ADDENDUM NO. 1

Project: State of Nebraska – Department of Roads
District 6 Oconto Maintenance Facility Project (AFE K-600)

Issued: July 1, 2014

2,000 GALLON DOUBLE WALL SKID TANK

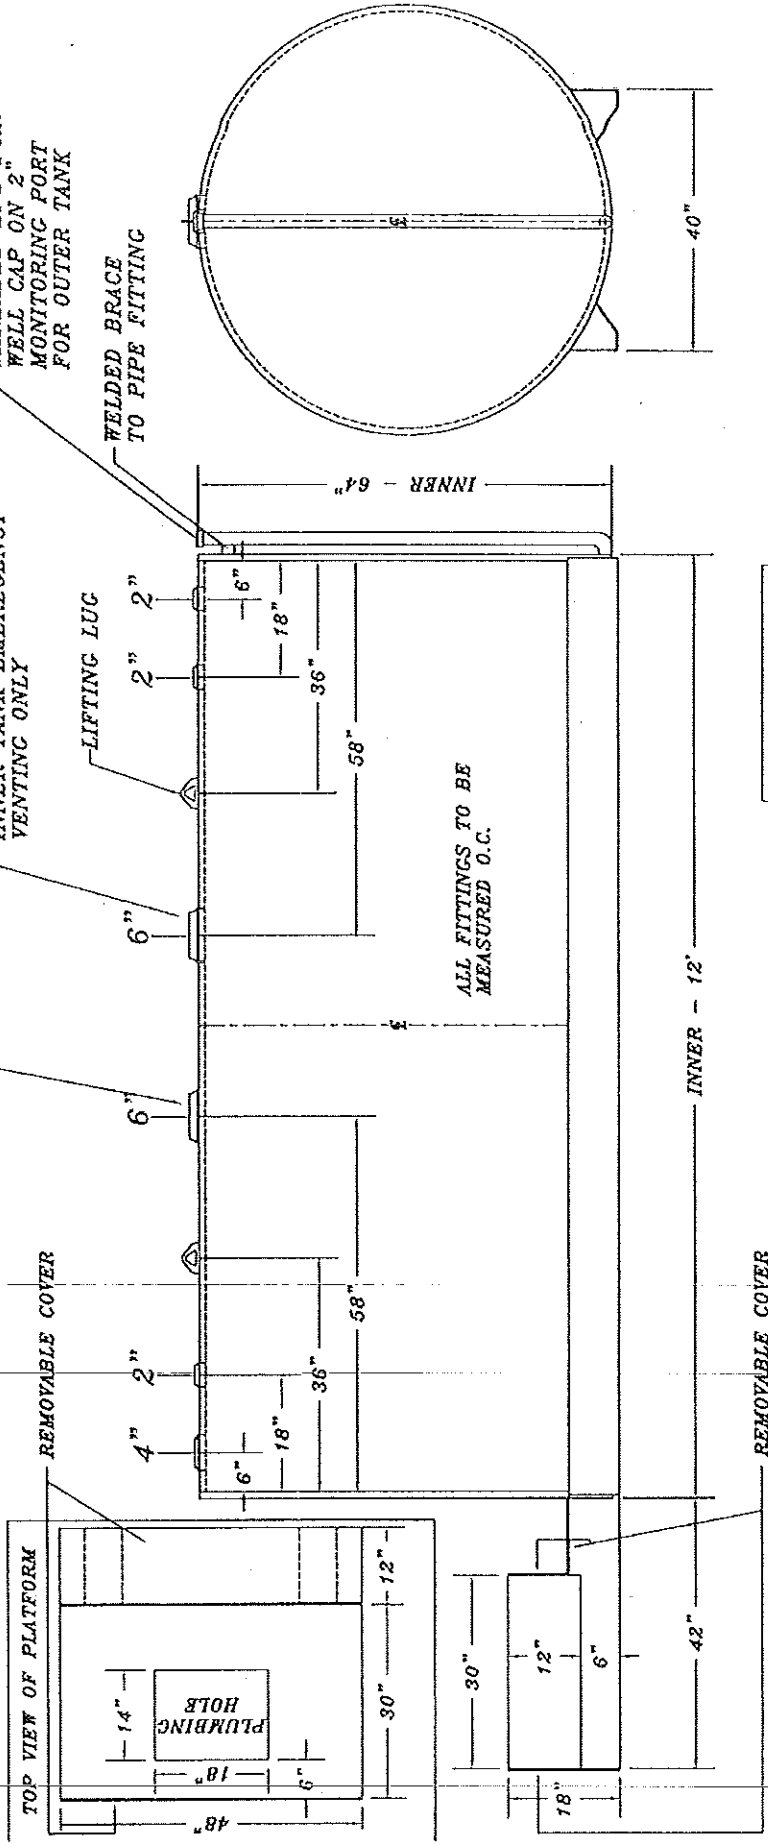
AD1.4. Specification Section 01 10 00. Part 1.05A, Item 3 references a cut sheet which was not included in the specifications. The attached cut sheet may be used for bidding purposes.
